Valmont Fashions (Extension)

11 March 2024

1. Building Information

Observation-1: Lack of lateral stability.

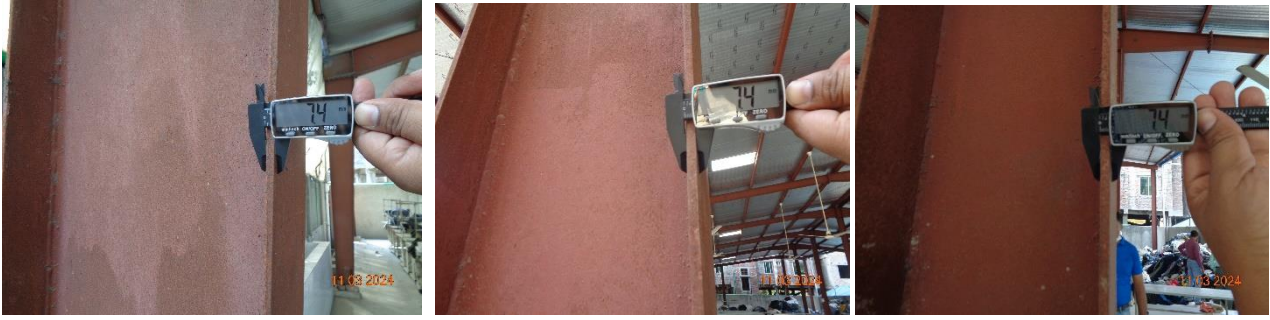
Description: During the inspection, Lateral load transfer media (compression strut) along the ridge and eaves were missing. The FEA model has been prepared considering the pipe compression strut, which was not installed at the site. Also, the geometry and roof bracing layout of the FEA model do not match the site drawing. The vertical cable bracing was found missing in one direction. The building engineer must check the lateral load path and revise the design documents based on as-built conditions.
